**JEMY DESIGN CORP.
ARCHITECT OF RECORD JOSUE CRUZ
JAVIER R. MARIN, DESIGNER AIA**

FILE NUMBER: 23-DP-52

SUBJECT: Preliminary Site Plan review for mixed-use development including 44 residential units and approximately 1,500 square feet of commercial space (Parkside Vue)

SHEET TITLE:
FIFTH FLOOR - EIGHTH FLOOR
ROOF

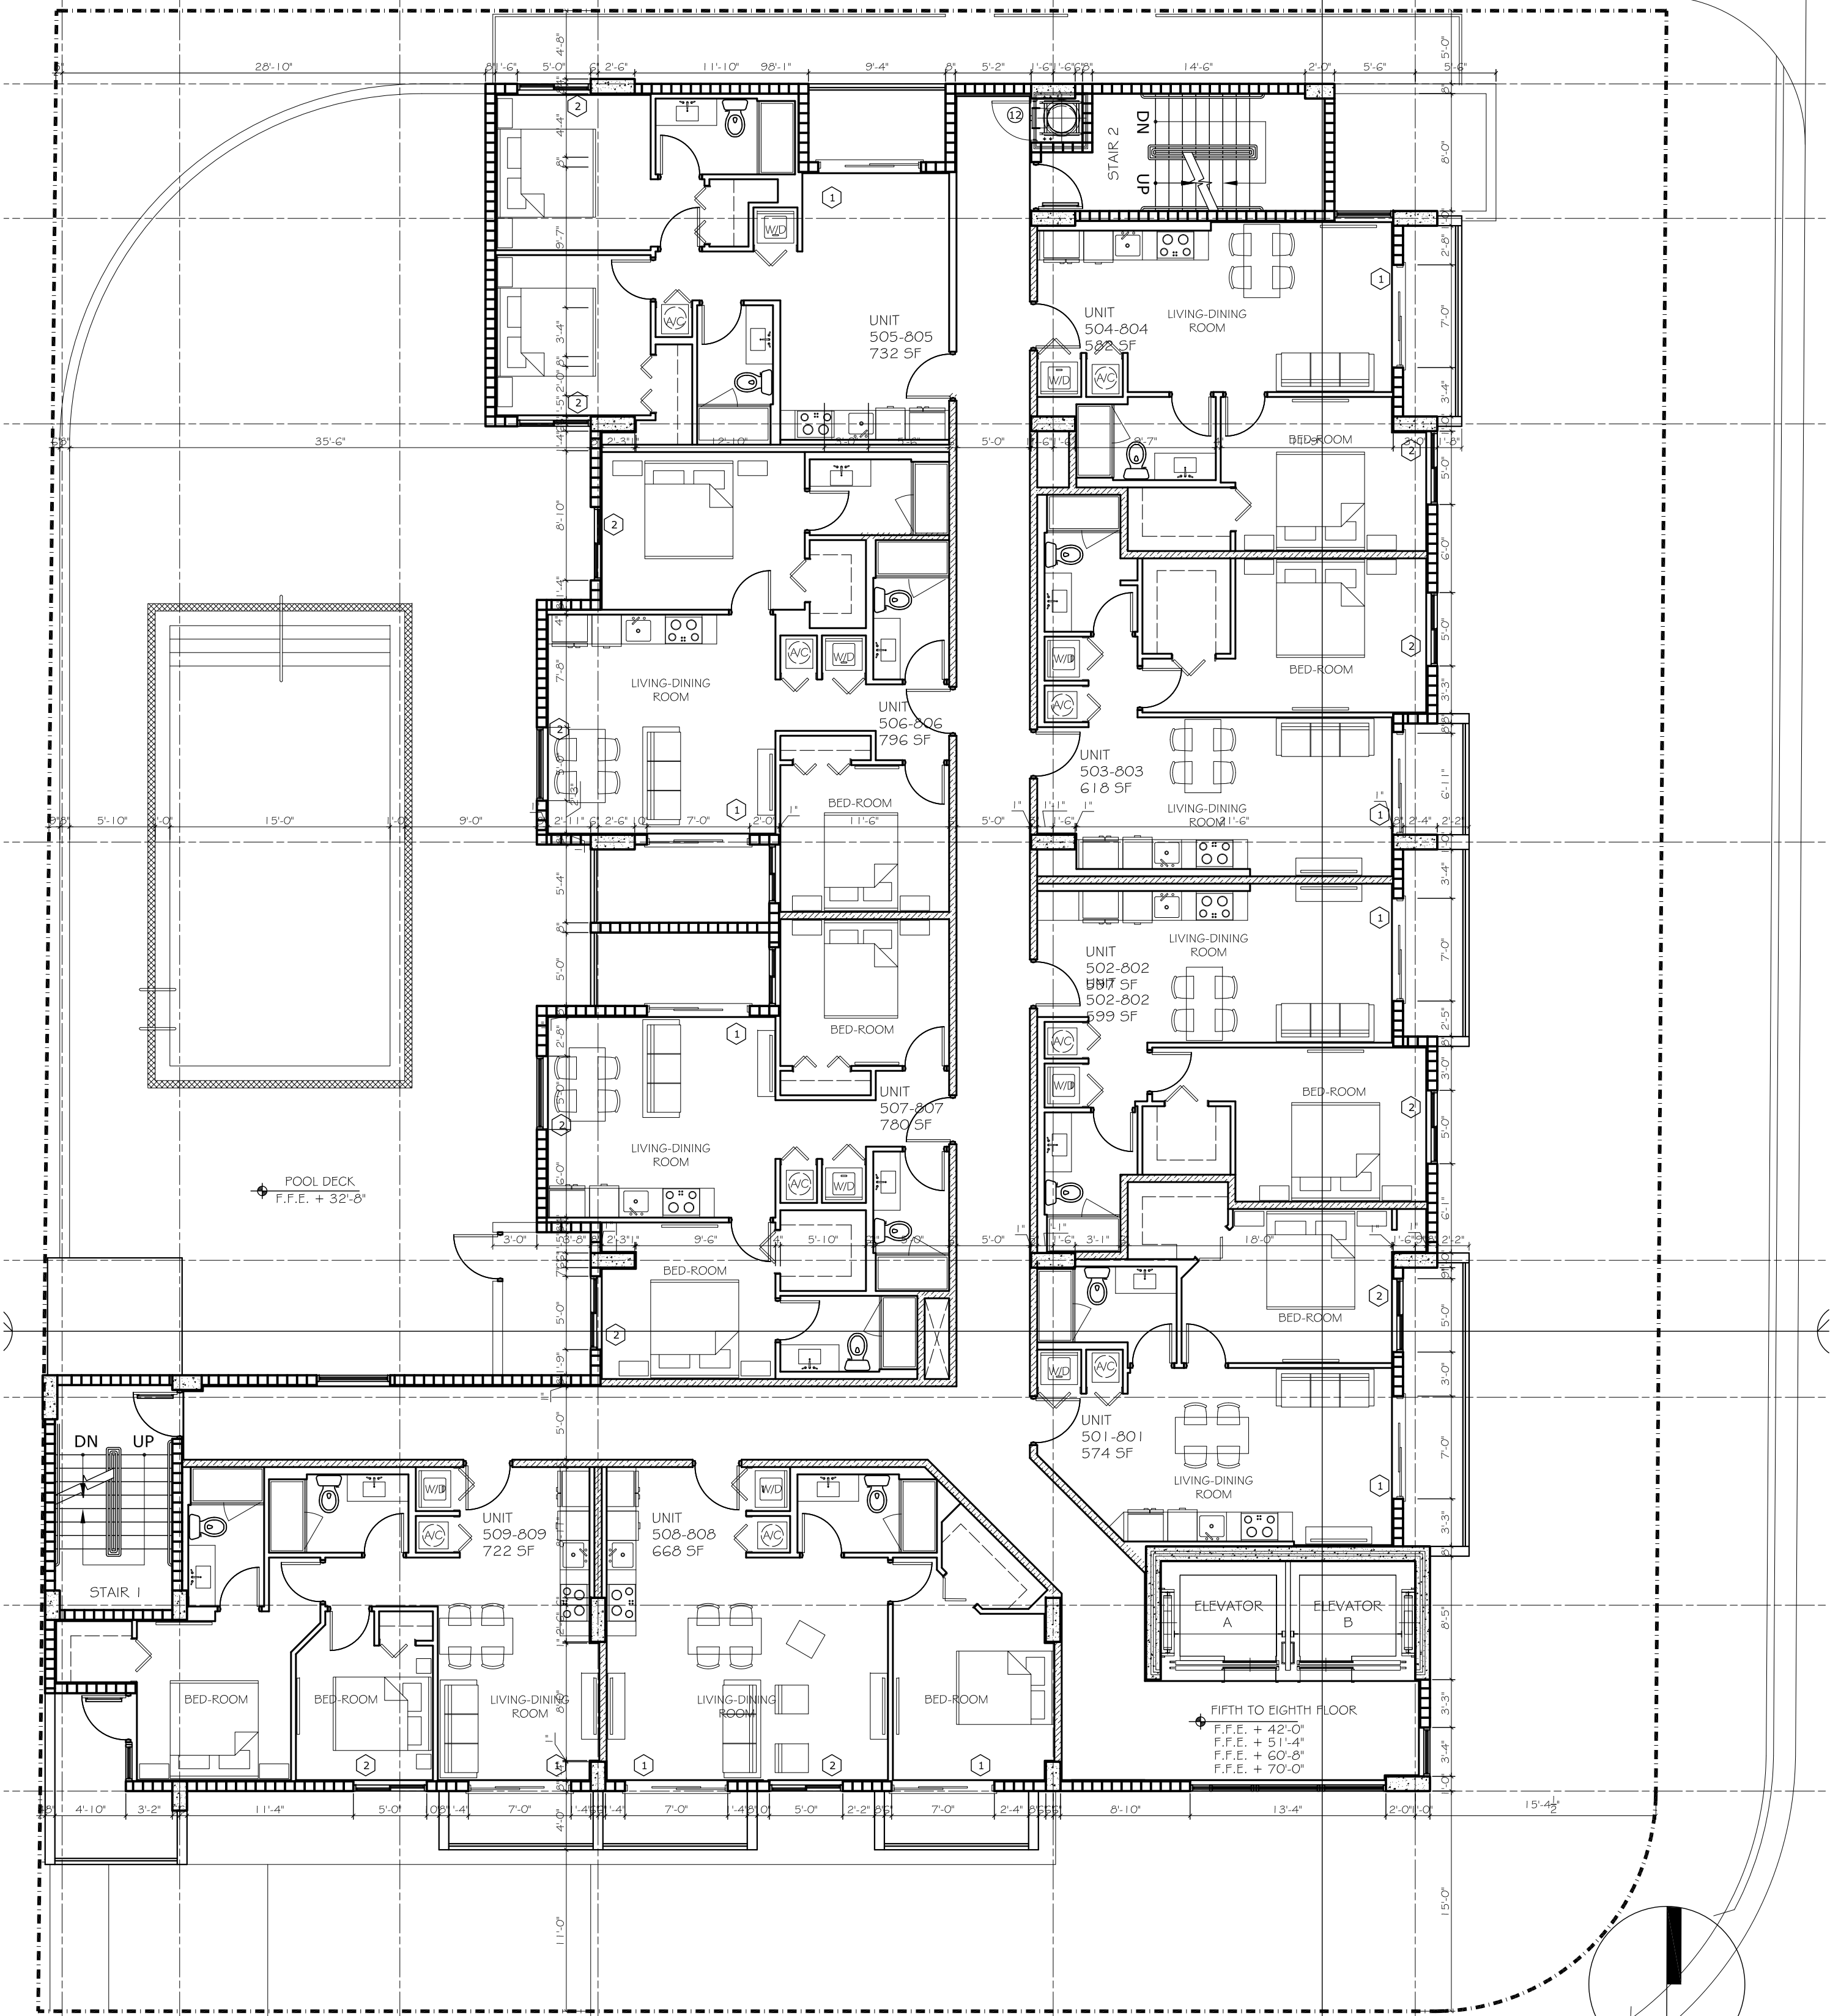
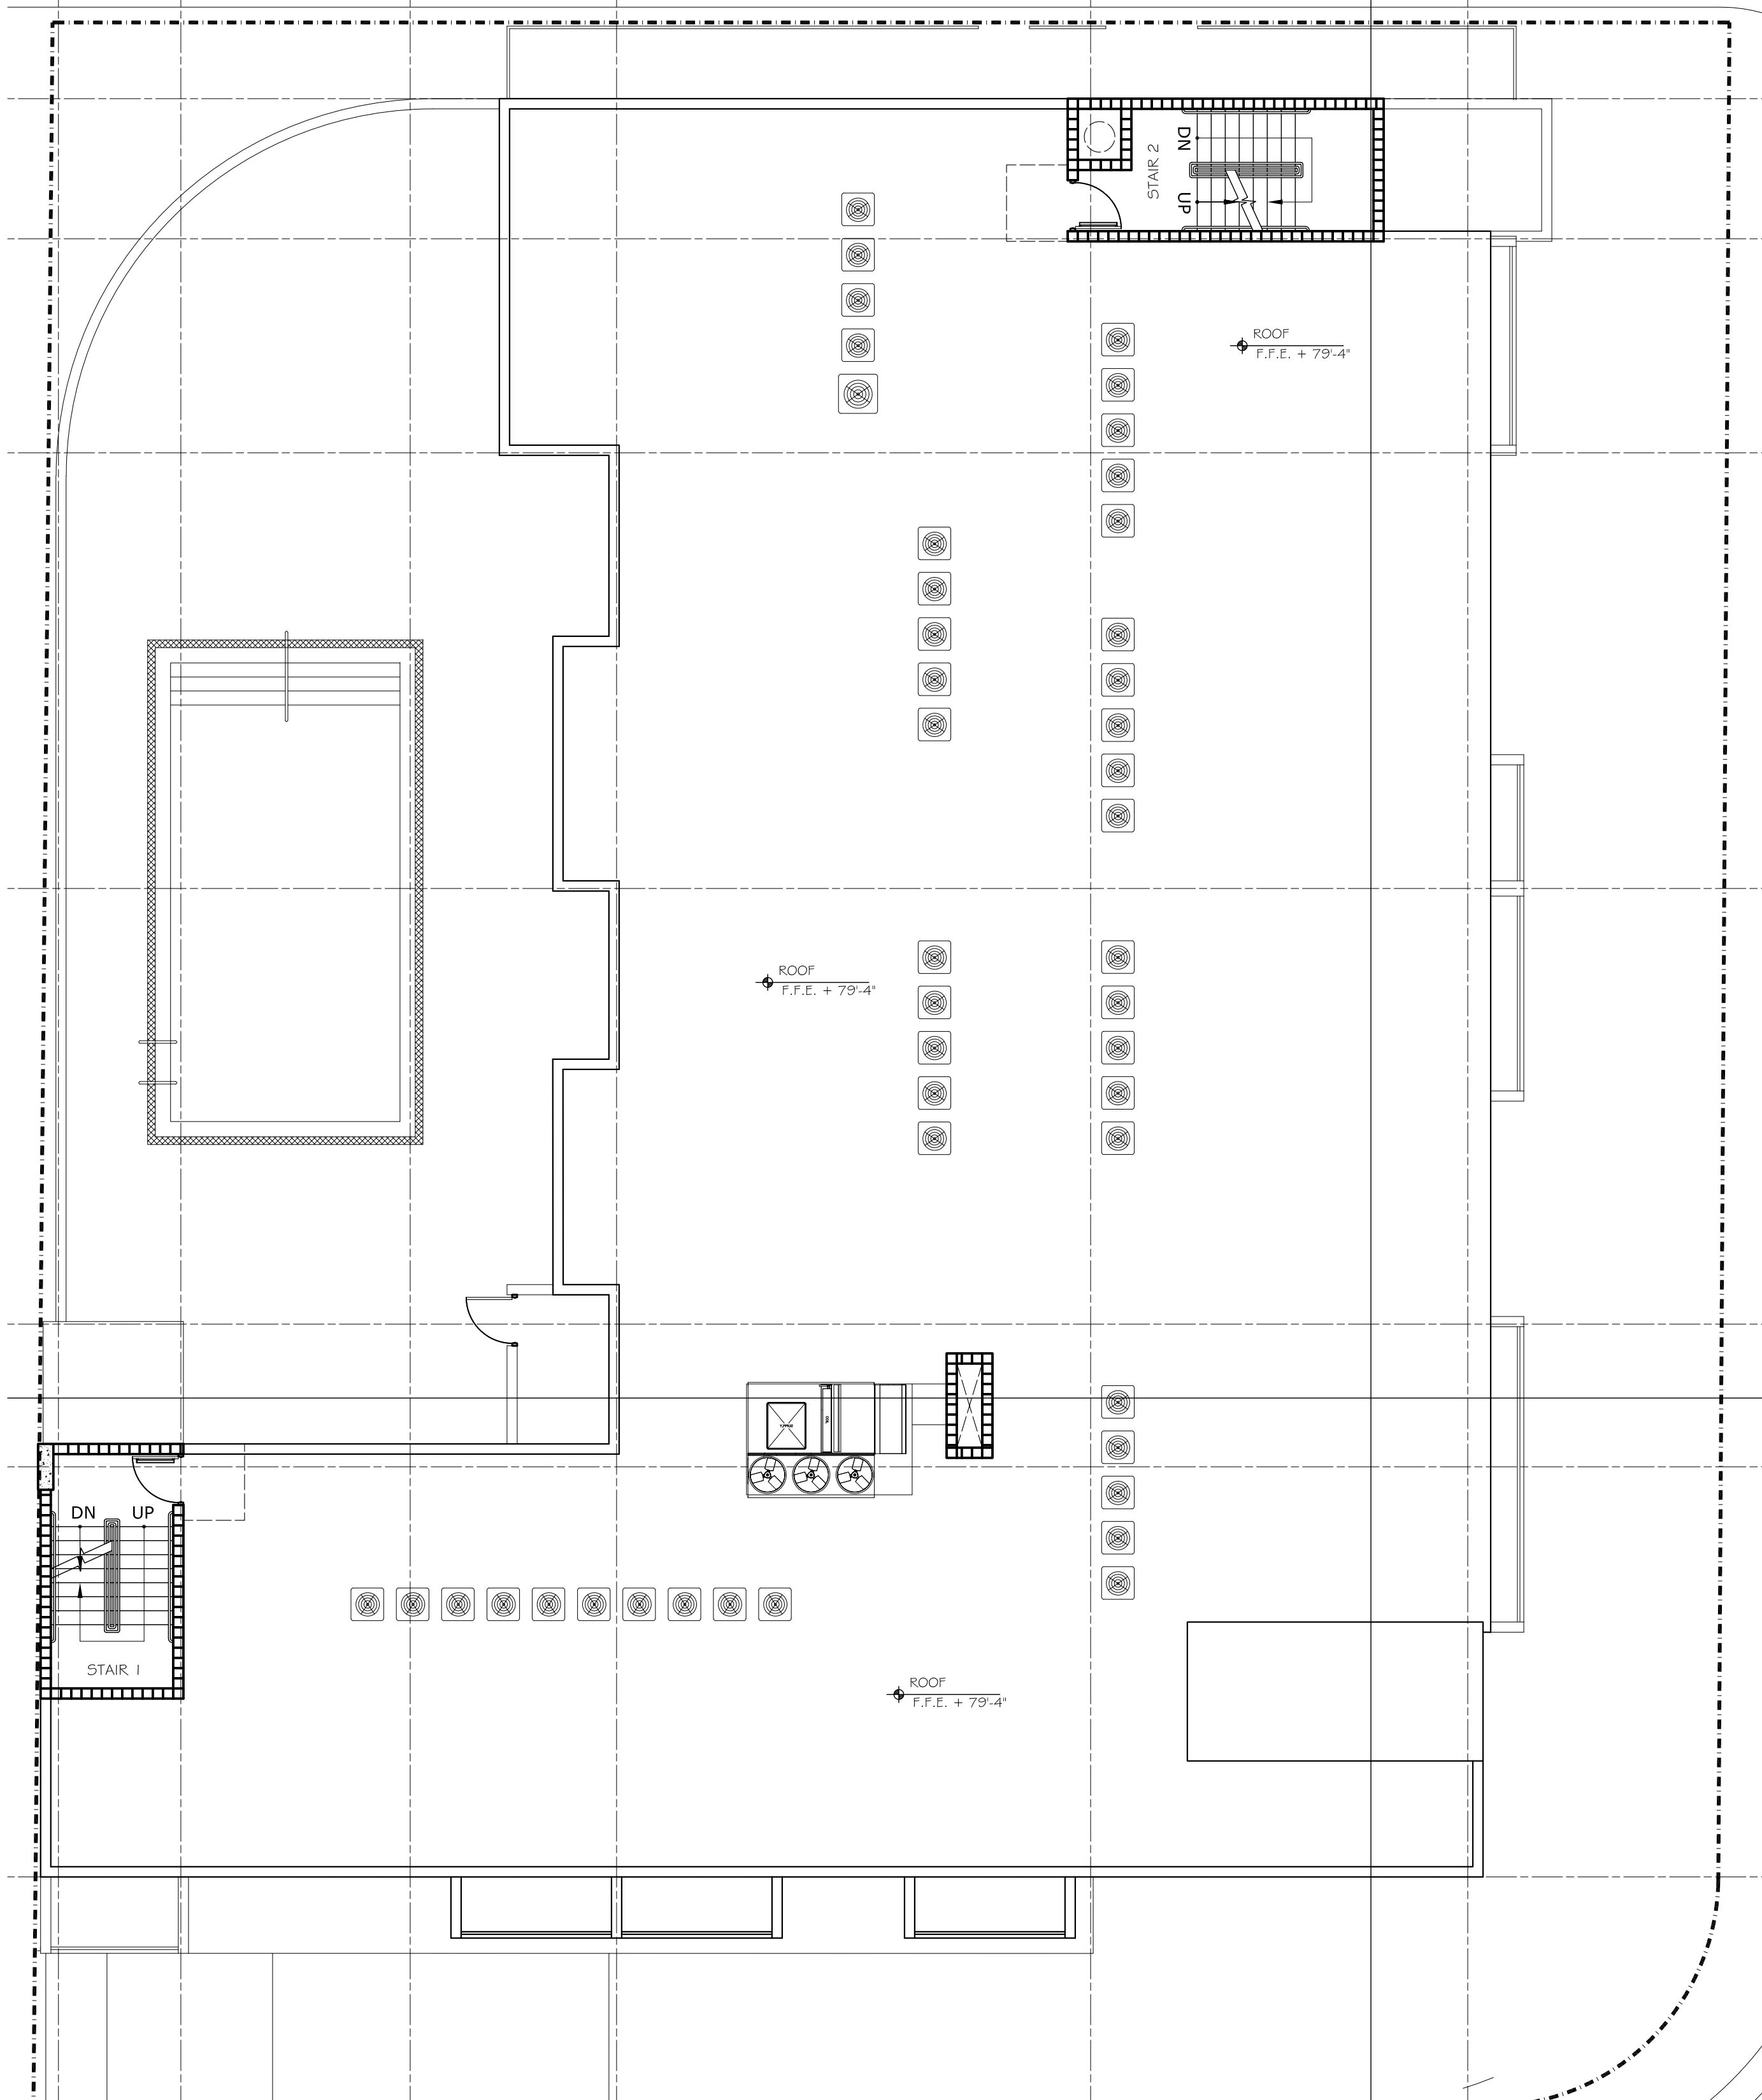
20. Please provide pavement marking to delineate between vehicle areas and pedestrian areas and ADA accessible routes. **PROVIDE ADA ROUTE A-001, A-007**

27. Please ADA accessible route for all ADA accessible parking stalls. Minimum ADA accessible route width is 5' with ADA compliant pavement marking. Show on site plan how ADA accessibility requirements are being met. ADA accessible route is required between accessibility parking and building access as well as accessible route to the public rights-of-way (Sidewalk) show routes on plans. Show any change in elevation along the route on the plan if the transition is flush identify the transition as flush on the plans, provide ramp slopes as applicable. Please add a note on the site plan and Civil plans stating any lip from 1/4" but not greater than 1/2" will be beveled to meet ADA requirements. **PROVIDE ADA ROUTE A-001, A-007**
